AGENDA SECTION: PUBLIC HEARING	ORIGINATING DEPT: PLANNING	ITEM NO. E-7
ITEM DESCRIPTION: Final Plat #02-31 to be known as Fox Hill Third Subdivision.		PREPARED BY: Mitzi A. Baker, Senior Planner

RE: Final Plat #02-31 by Fox Hill, LLC to be known as Fox Hill Third Subdivision. The Plat proposes to subdivide approximately 20.01 acres of land into 30 lots for single family detached dwellings and 3 outlots. The plat also dedicates the right of way for new public roadways. The property is located along the north side of Fox Valley Drive SW and south of Whitney Lane SW.

FINAL PLAT # 02-31

SHEET 3 OF 3 SHEETS

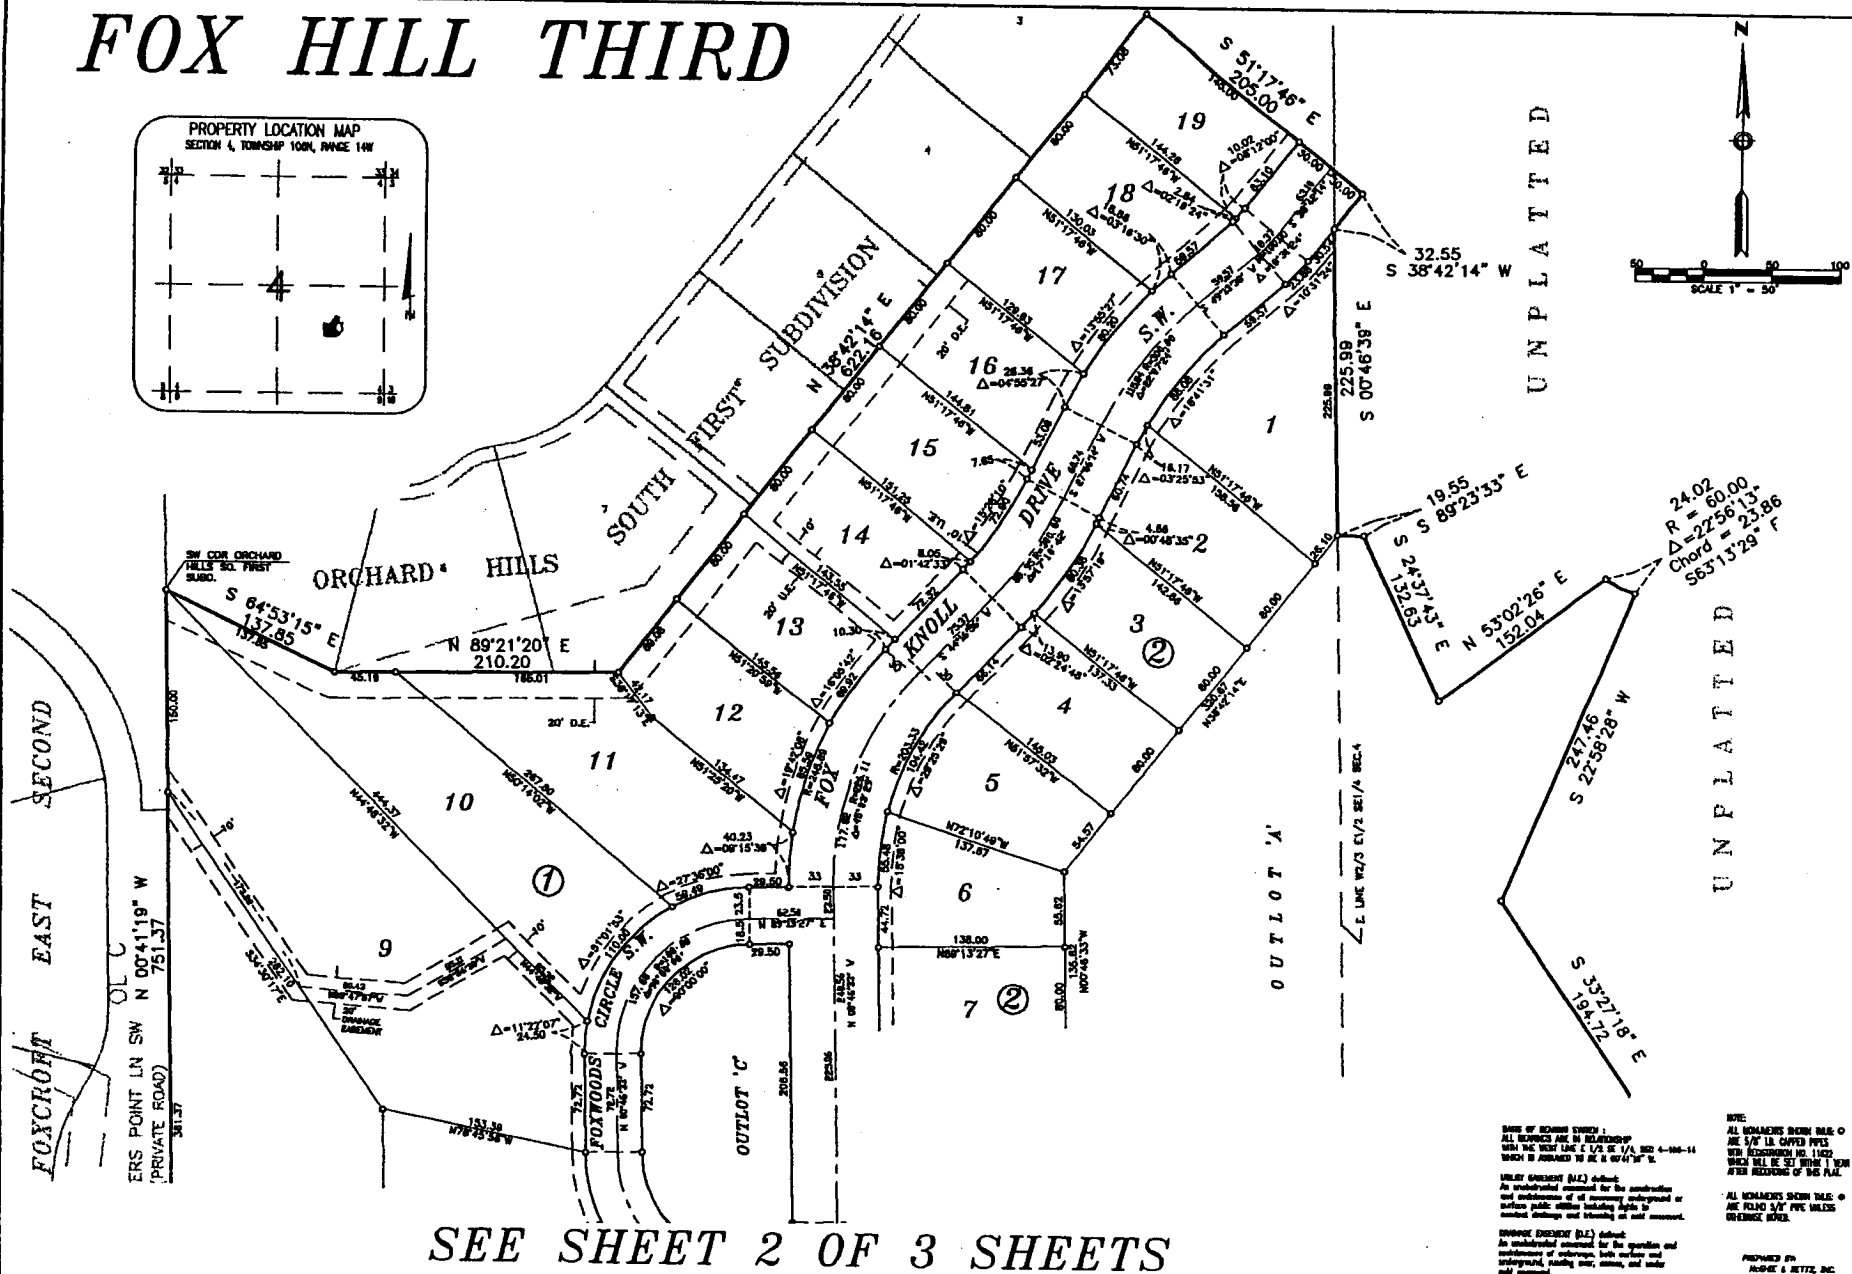
1. **FOXWOODS CIRCLE SW** is still using the incorrect roadway type.

RECOMMENDATION: Change the roadway type to **COURT**. (**FOXWOODS COURT SW**).
